Office Action Summary

10/615,407

SANTISI, PHILLIP M.

DETAILED ACTION

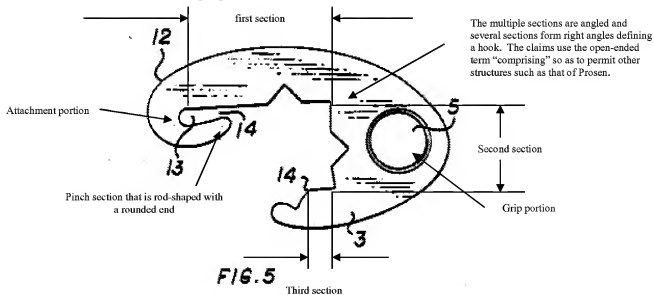
Claims 1, 6-9, 11, 15, 16, 18, 19, 21 and 42 are rejected under 35 U.S.C. 102(b) as being clearly anticipated by Prosen (US 5035558).

Prosen (figure 5) teaches a clasp 3 comprising a hook portion, a grip portion and an attachment portion, the hook portion comprising a first section, a second section and a third section, wherein the first section is connected to and perpendicular with the second section, the second section connected to and perpendicular with the third section.

Prosen utilizes fabric-jacketed elastic cords, which is inherently a bungee cord, to secure loads such as cargo to vehicle racks wherein the configuration of the hook portions are adaptable to securement to a variety of surfaces such as polygonal, cylindrical and irregular surfaces. As claim 1 utilizes the open-ended language “comprising” and the pinch section identified above is rod-shaped with a rounded end thereby meeting the claim language while permitting other structure such as the flattened plate portions extending from the rod-shaped pinch section with a rounded end. Further, applicant doesn’t use --consisting-- so as to preclude any other structure such as the notches in the middle of the straight first and straight second sections.

As to claims 6 and 7, these relative dimensions are formed by sections of the hook portion of Prosen’s device. In regard to claim 8, figure 6 of Prosen shows the hook portion in a single plane. As to claim 9, figure 5 shows that it is possible to configure planes perpendicular to the plane of the paper and aligned with the first and third sections. In regard to claim 11, the claims utilize the open-ended language “comprising” and the pinch section identified above is rod-shaped with a rounded end so as to meet the claim language while permitting other structure. As to claim 15, the pinch section identified above is between and therefore separates the grip portion from the attachment portion. In regard to claim 16, the pinch section identified above pinches the cord and therefore keeps that portion of the cord from entering the grip portion 5. As to claim 18, cargo is considered equipment for a purpose. In regard to claims 21 and 42, as pointed out above there are multiple straight angled portions connected together to form a hook portion.

**FIG. 5**

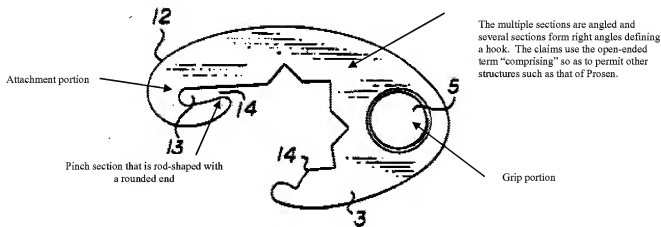
Claims 2-5, 12, 13, 22-24, 26-28, 30 and 31 are rejected under 35 U.S.C. 103(a) as being unpatentable over Prosen (US 5035558) in view of Chuan (US 4831692).

Prosen (figure 5) teaches a clasp 3 comprising a hook portion, a grip portion and an attachment portion, the hook portion comprising a first section, a second section and a third section, wherein the first section is connected to and perpendicular with the second section, the second section connected to and perpendicular with the third section.

Prosen utilizes fabric-jacketed elastic cords, which is inherently a bungee cord, to secure loads such as cargo to vehicle racks wherein the configuration of the hook portions are adaptable to securement to a variety of surfaces such as polygonal, cylindrical and irregular surfaces. The difference with regard to claim 2 is that the hook of figure 5 is an intermediate hook rather than being found at the ends of the cord. However, Chuan (figures 1-3, 5, 7) teaches that it is desirable to secure clasps with grip portions at the ends of the cord without intermediate hooks wherein there are reduced gaps in the attachment portions that would pinch the cord in a similar manner to that of Prosen. As Prosen teaches that it is desirable to configure the hook portion with perpendicular portions for both the end hooks and the intermediate hooks and Chuan teaches that it is desirable to secure clasps with grip portions at the ends of the cord without intermediate hooks wherein there are reduced gaps in the attachment portions that would pinch the cord, it would have been obvious to modify the end hooks of Prosen so as utilize hooks with a pinching portion at the ends as taught by Chuan while maintaining the perpendicular sections taught by Prosen since Prosen wishes to keep the angular hook portion because of its greater use in securing the clasp to various shapes. As to claim 5, the devices of Prosen and Chuan describe the typical bungee cord that is well known. In regard to claim 22, this claim is rejected for the reasons identified for claim 2 with the further observation that the pinch section identified above with respect to Prosen pinches the cord and therefore keeps that portion of the cord from entering the grip portion 5. As to claims 12, 13, 27 and 28, Chuan teaches that the use of steel is conventional for forming the hooks as would be expected because of its strength (col. 1, lines 19-25).

FIG. 5

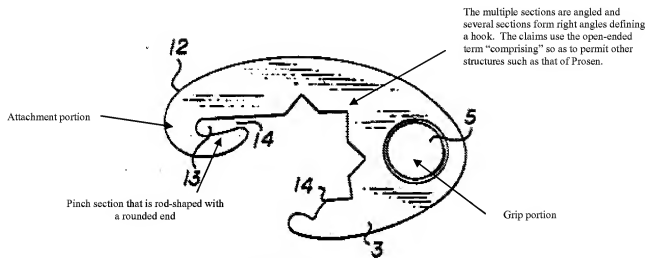
Claims 12-14 are rejected under 35 U.S.C. 103(a) as being unpatentable over Prosen (US 5035558) in view of Simon (US 3328064).

Prosen (figure 5) teaches a clasp 3 comprising a hook portion, a grip portion and an attachment portion, the hook portion comprising a first section, a second section and a third section, wherein the first section is connected to and perpendicular with the second section, the second section connected to and perpendicular with the third section.

Prosen utilizes fabric-jacketed elastic cords, which is inherently a bungee cord, to secure loads such as cargo to vehicle racks wherein the configuration of the hook portions are adaptable to securement to a variety of surfaces such as polygonal, cylindrical and irregular surfaces. The difference is that while metal is stated as being a material (col. 2, lines 15-17), steel and aluminum are not stated as being used. It would have been obvious to utilize either steel or aluminum in view of Simon (figure 2) teaching the use of aluminum or steel as being desirable for clasps because of their ability to resist corrosion (col. 3, lines 8-12).

FIG. 5

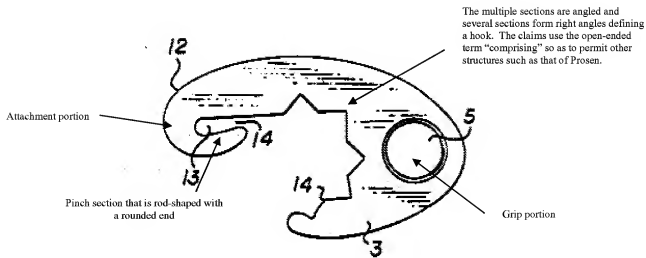
Claim 17 is rejected under 35 U.S.C. 103(a) as being unpatentable over Prosen (US 5035558) in view of Yonts (US 4842236).

Prosen (figure 5) teaches a clasp 3 comprising a hook portion, a grip portion and an attachment portion, the hook portion comprising a first section, a second section and a third section, wherein the first section is connected to and perpendicular with the second section, the second section connected to and perpendicular with the third section.

Prosen utilizes fabric-jacketed elastic cords, which is inherently a bungee cord, to secure loads such as cargo to vehicle racks wherein the configuration of the hook portions are adaptable to securement to a variety of surfaces such as polygonal, cylindrical and irregular surfaces. The difference is that the first section doesn't separate the grip portion from the second and third sections of the hook portion. Relocation of the grip portion of the device of Prosen so that the first section separates the grip portion from the second and third sections of the hook portion would have been obvious in view of Yonts (figures 2, 3) teaching placing the grip portion 10 so that the first section separates the grip portion from the second and third sections of the hook portion so as to provide a useful way to apply force to attach the hook portion.

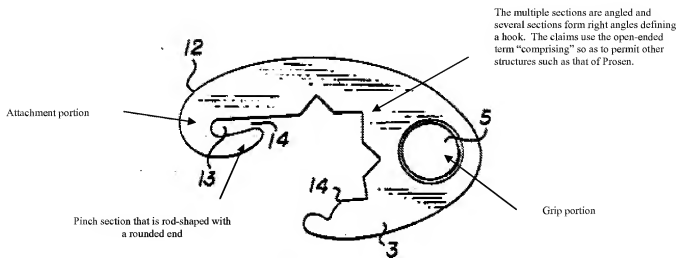
Claim 25 is rejected under 35 U.S.C. 103(a) as being unpatentable over Prosen (US 5035558) in view of Chuan (US 4831692) as applied to claim 22 above, and further in view of Yonts (US 4842236).

Further modification of the metal clasp of Prosen so that the first section separates the grip portion from the second and third sections of the hook portion would have been obvious in view of Yonts (figures 2, 3) teaching placing the grip portion 10 so that the first section separates the grip portion from the second and third sections of the hook portion so as to provide a useful way to apply force to attach the hook portion.
